SUBJECT: ACCC – LOADING DOCK REMEDIATION PHASE II – ADDENDUM #3

ATLANTIC CITY CONVENTION CENTER
LOADING DOCK TRENCH DRAIN REPLACEMENT AND RELATED WORK
ADDENDUM #3
AUGUST 15, 2024

PROJECT:
LOADING DOCK REPAIRS
ATLANTIC CITY
CONVENTION HALL
ATLANTIC CITY, NEW JERSEY

ACCC LOADING DOCK TRENCH DRAIN
REPLACEMENT PHASE II
ADDENDUM #3
EAST END
08-15-24

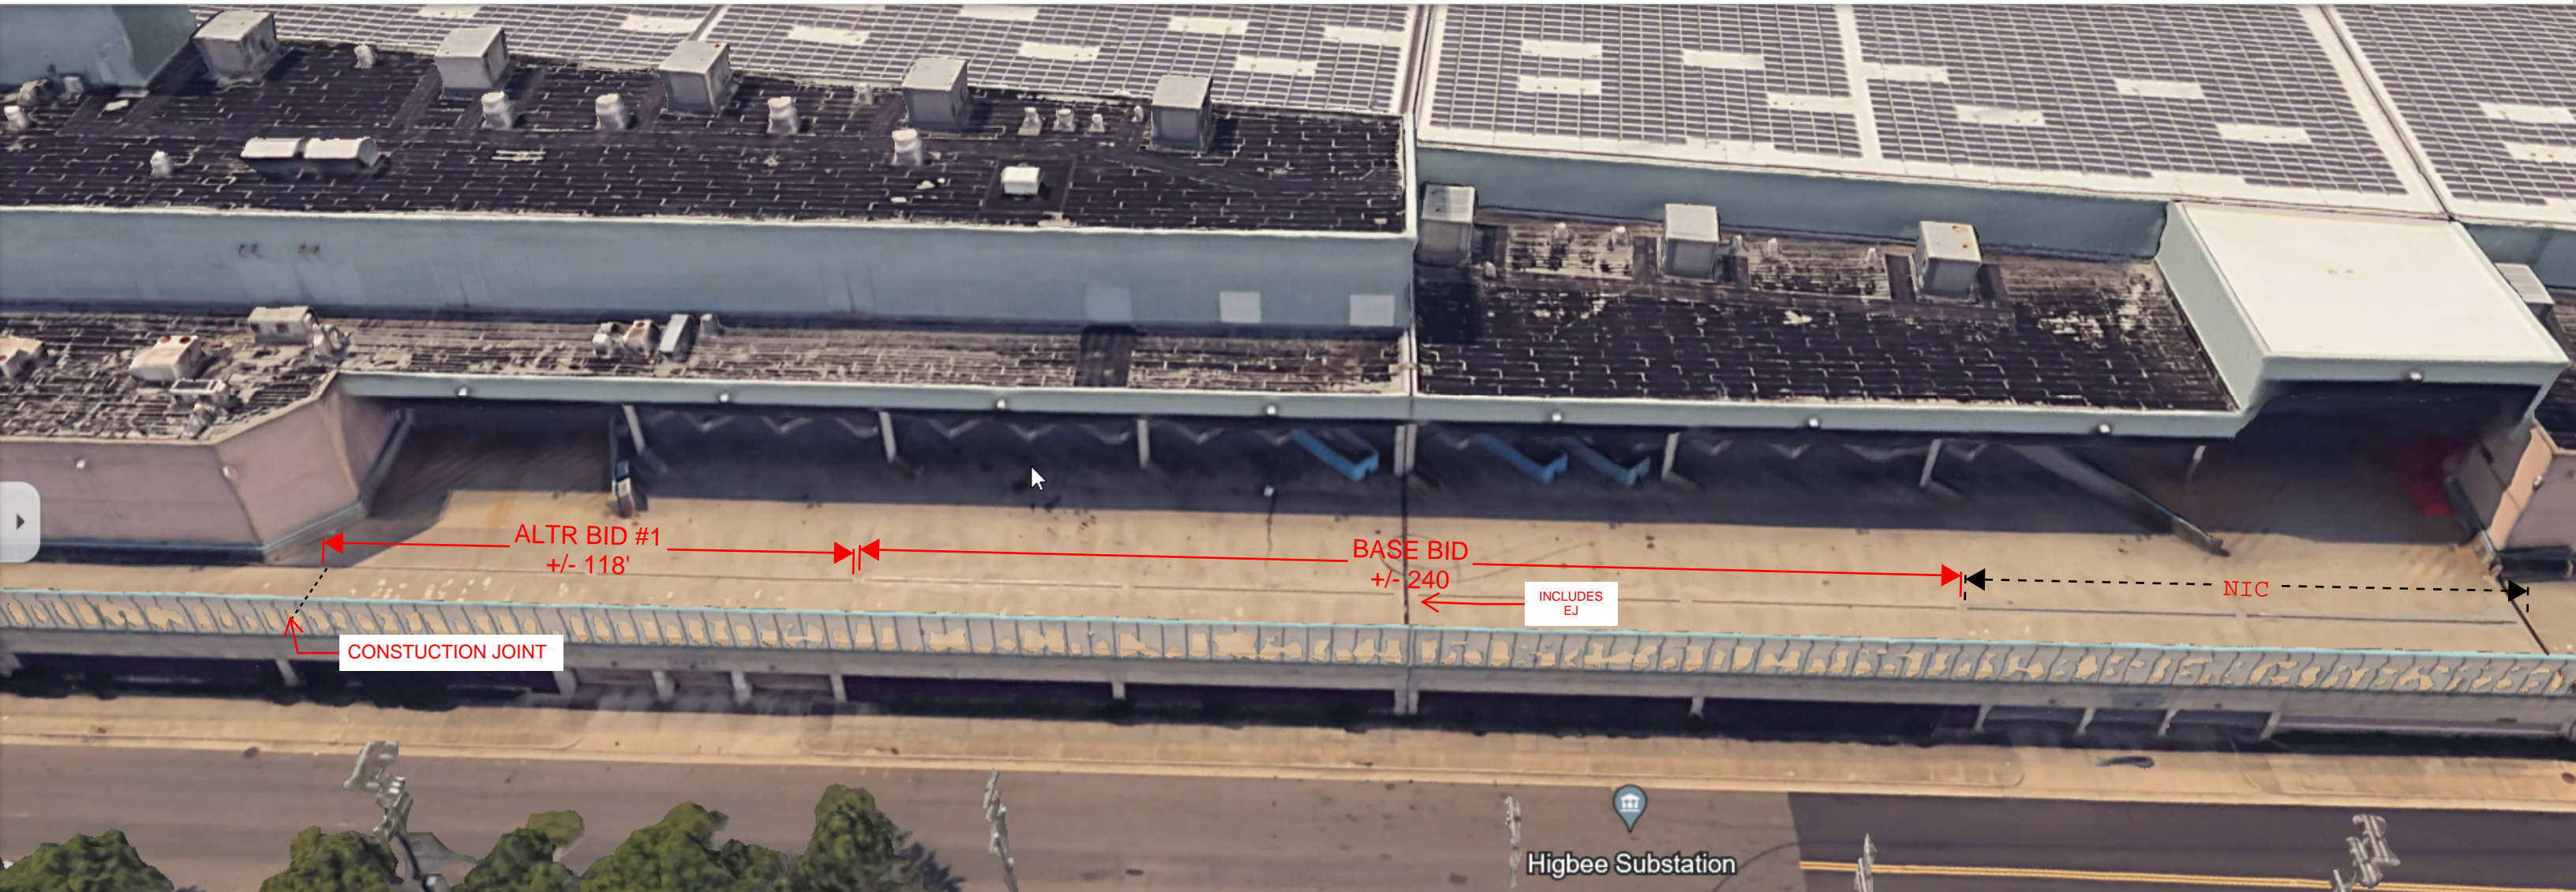
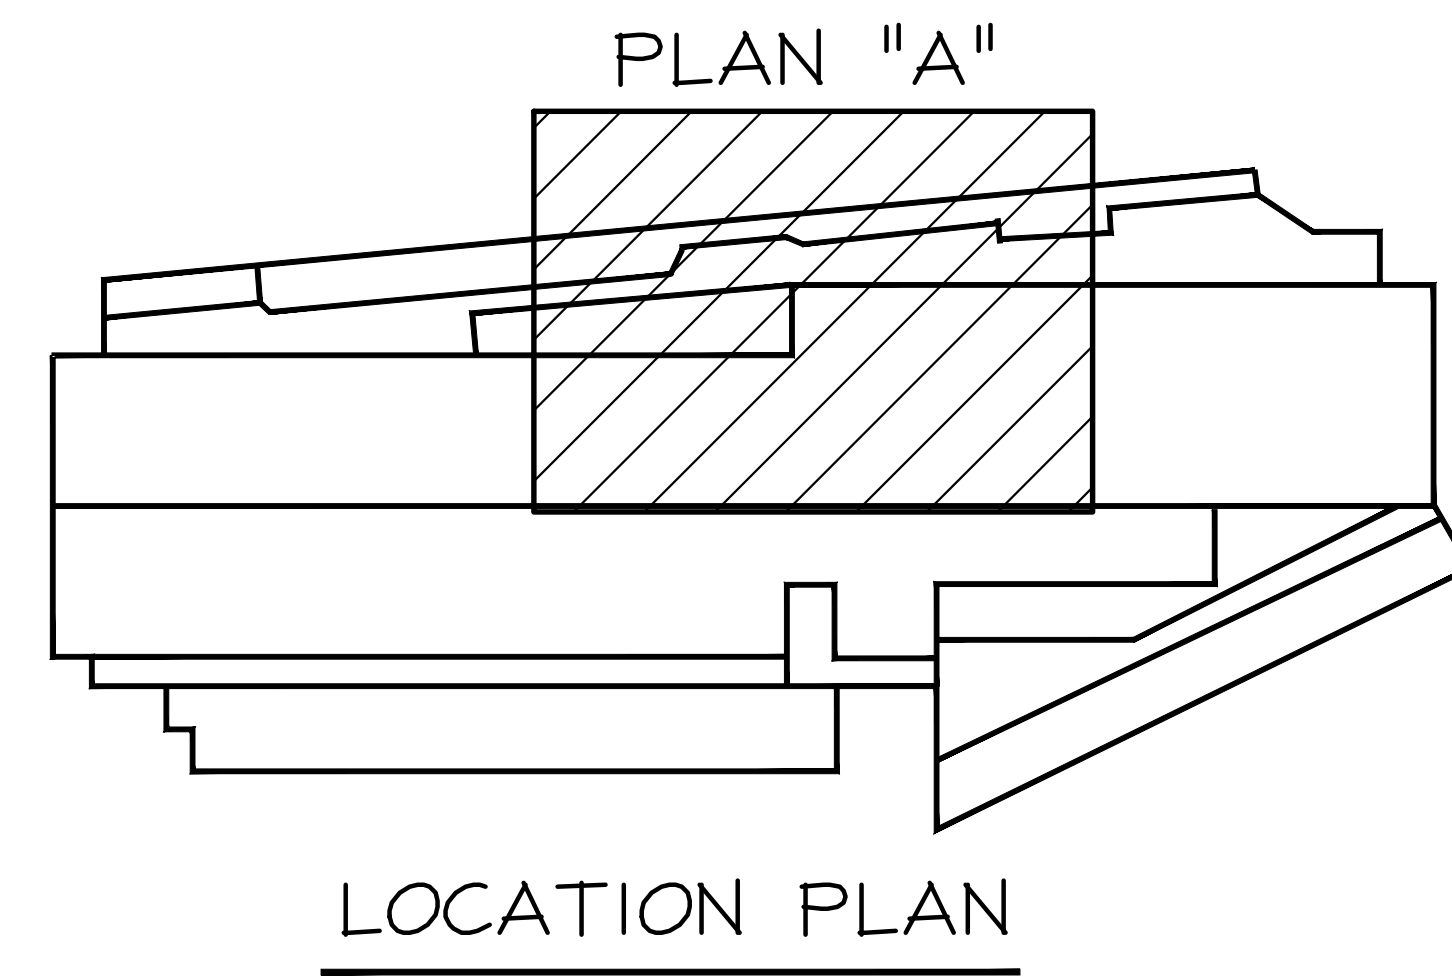
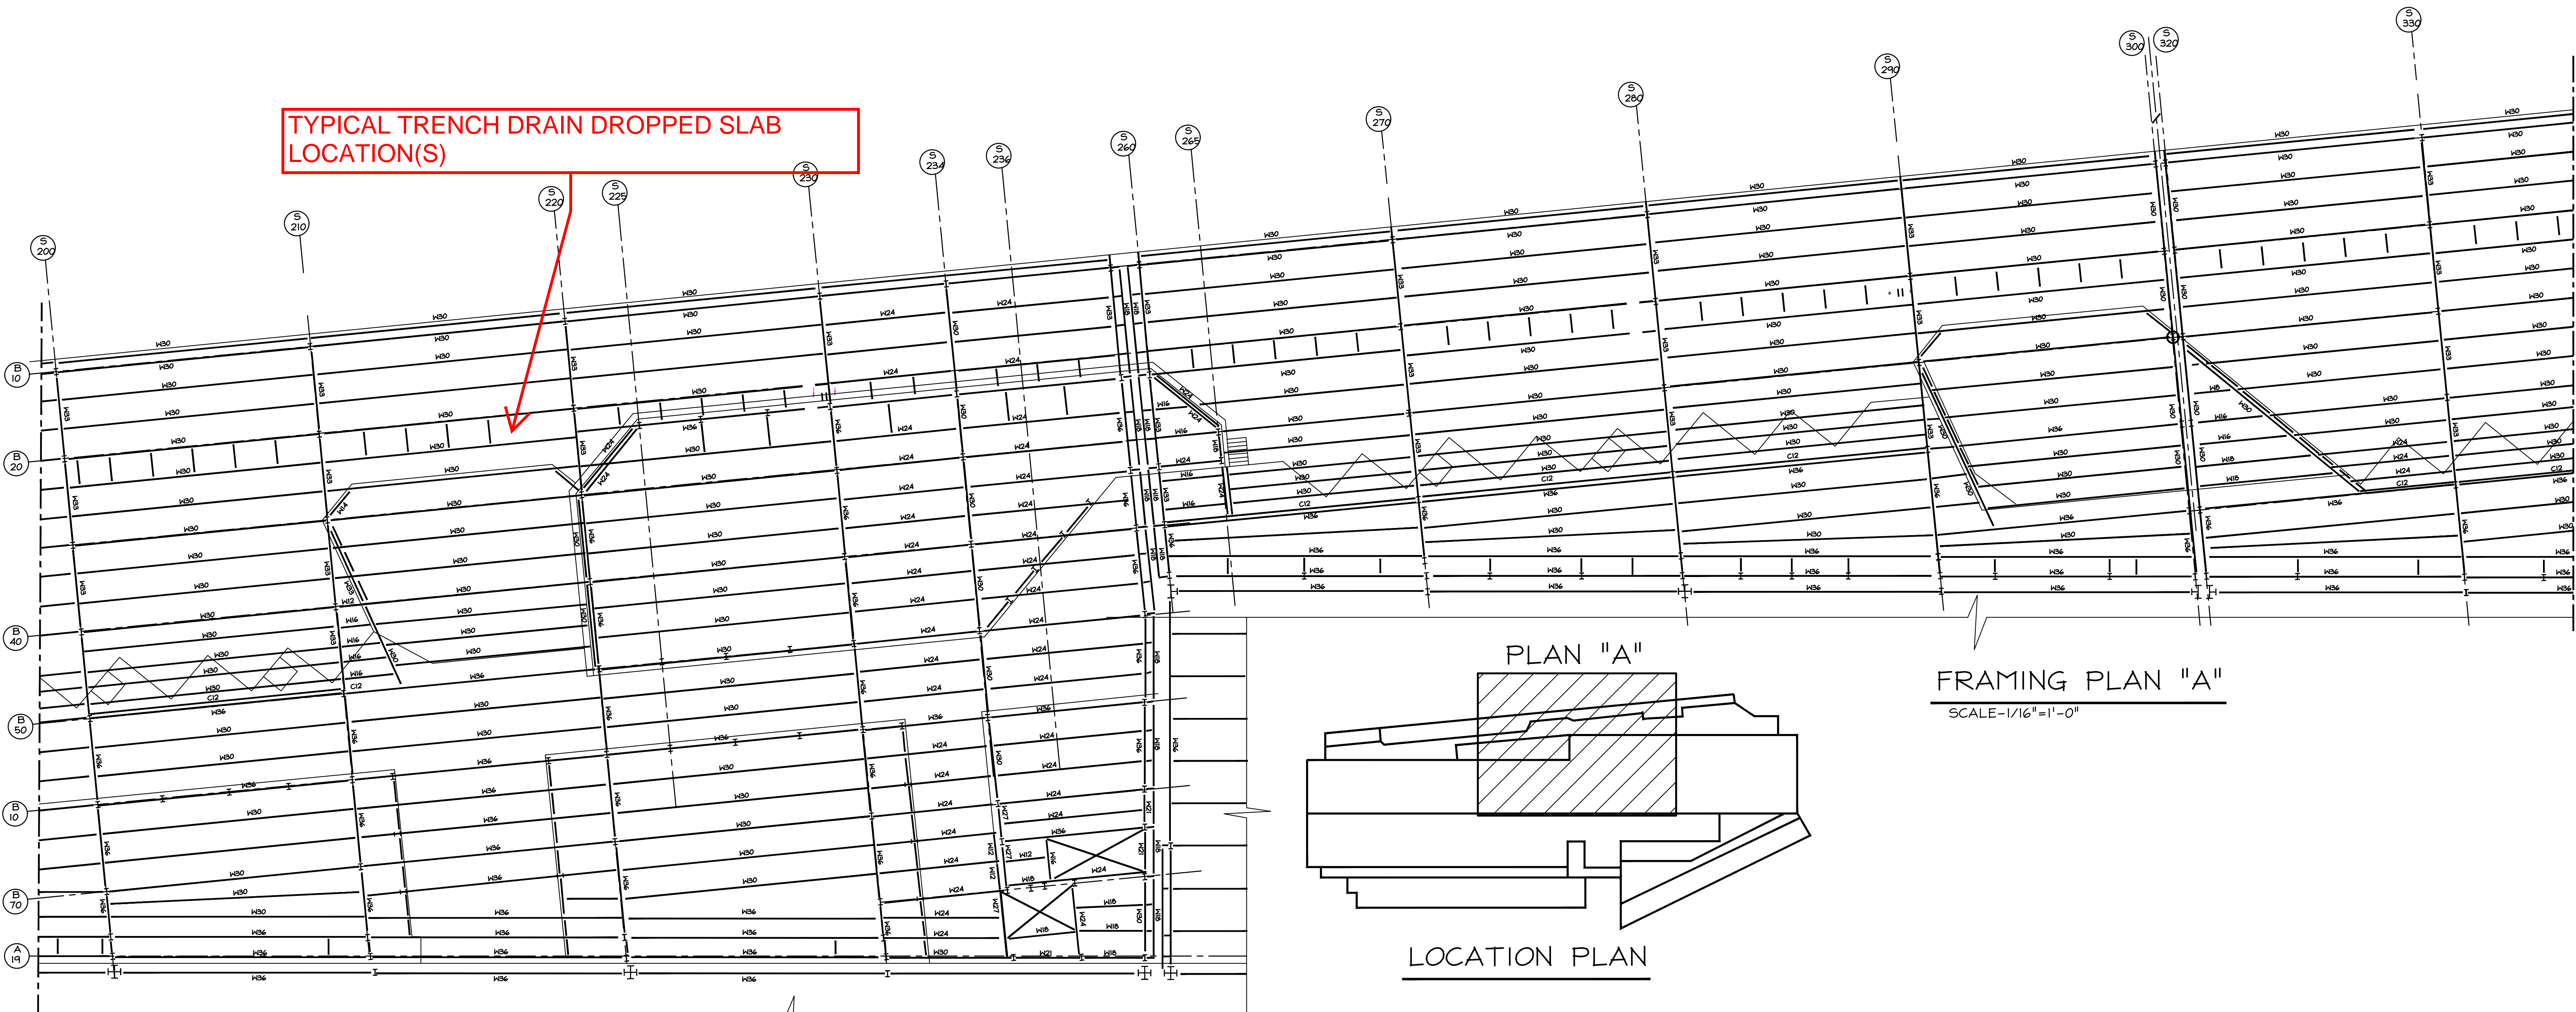
- a. Correct – See steel framing plan.
7. Per the Site Visit on 8-7-24 please provide a revised Base Bid and Alternate Drawing that accurately depicts the existing conditions and either includes dimensions or includes a scale.

- a. See attached.
8. Per the Site Visit on 8-7-24 please provide the missing "S" drawing for Plan "A".
 - a. See attached.
9. Per the Site Visit on 8-7-24 please clarify extent (limits) of expansion joint removal and replacement. Whether the sidewalk area is included or any vertical joints etc....

SHEET TITLE:
FRAMING PLANS

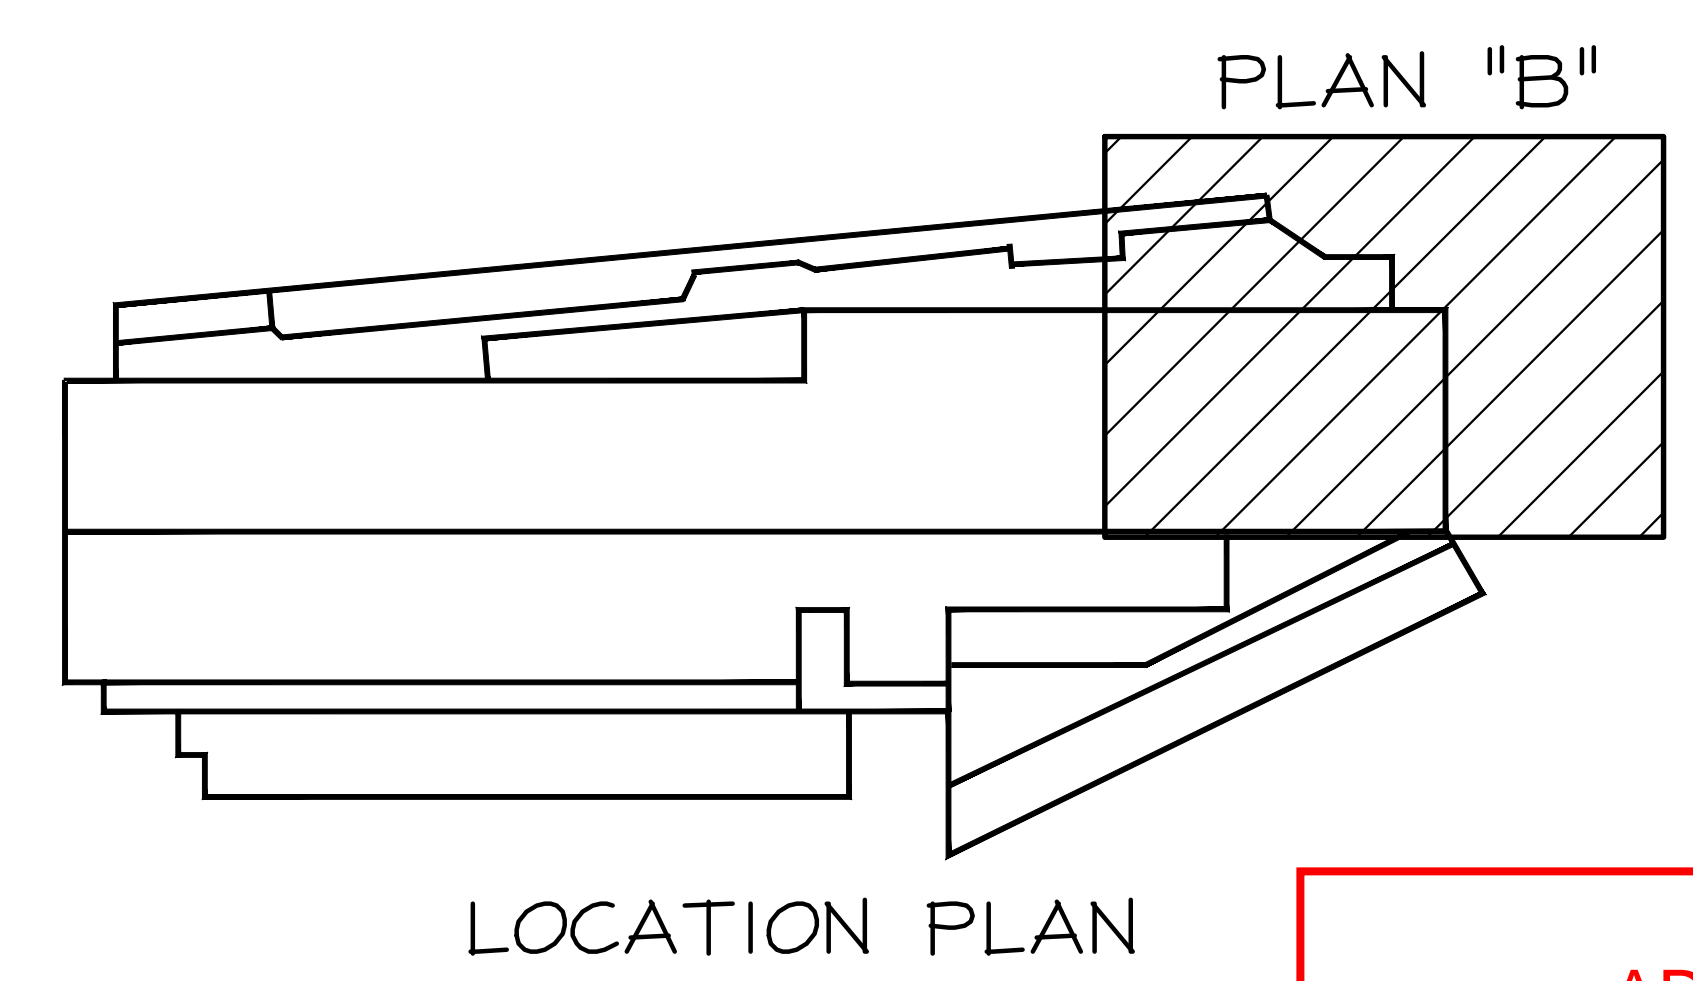
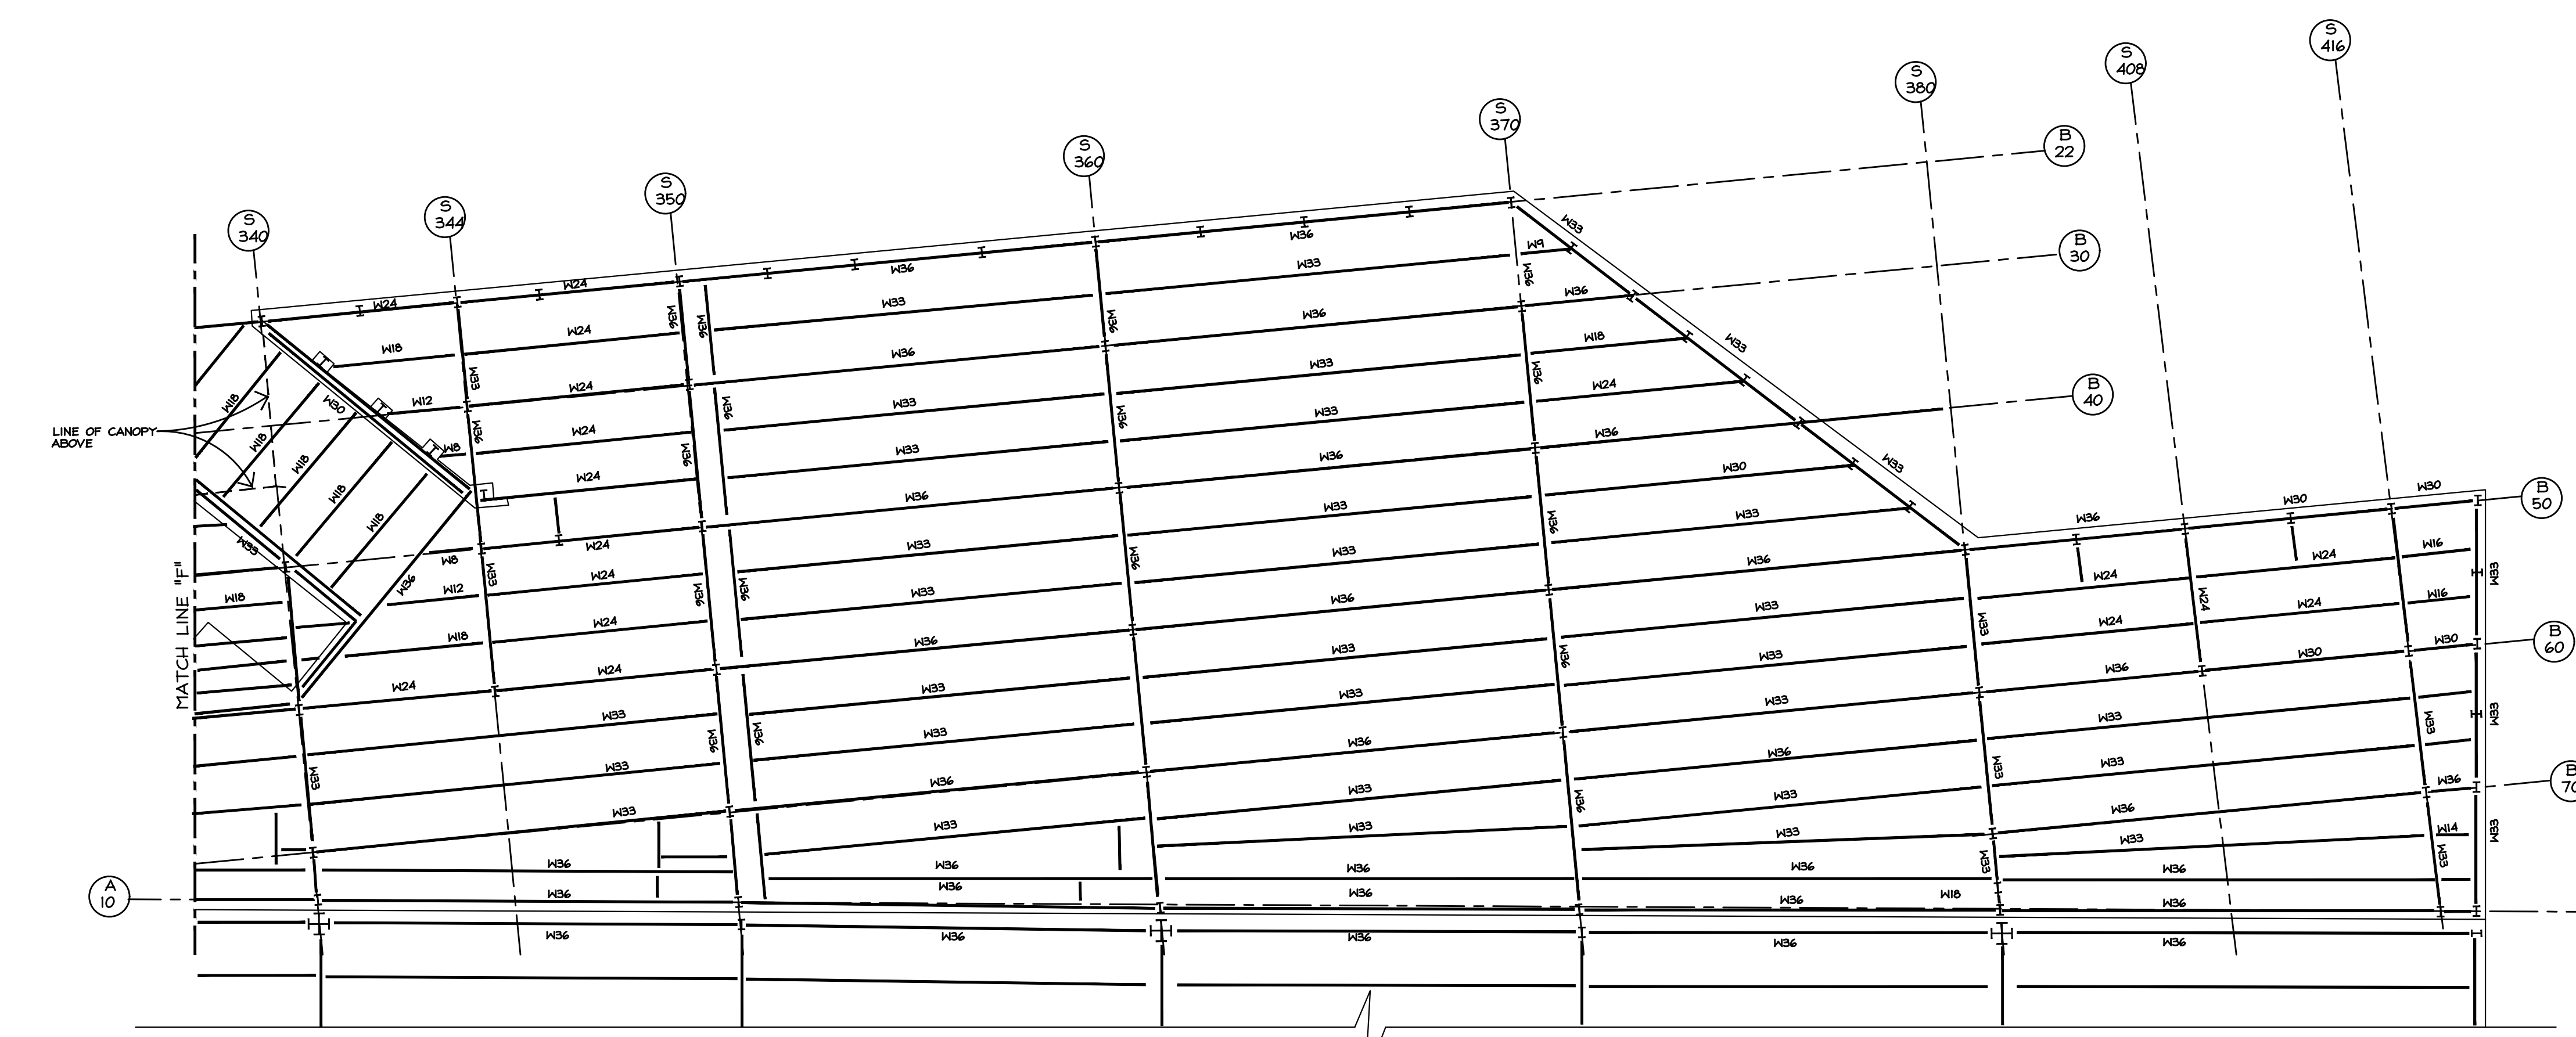
- a. Correct
5. Per the Site Visit on 8-7-24 please confirm - The steel fireproofing removal at the trench drain is limited to the first parallel beams on each side of the lower trench slab and any additional cross beams between the two.

- a. Correct. See existing framing plan.
6. Per the Site Visit on 8-7-24 please confirm - The steel fireproofing removal at the expansion joint is limited to the first parallel beam on each side of the expansion joint.
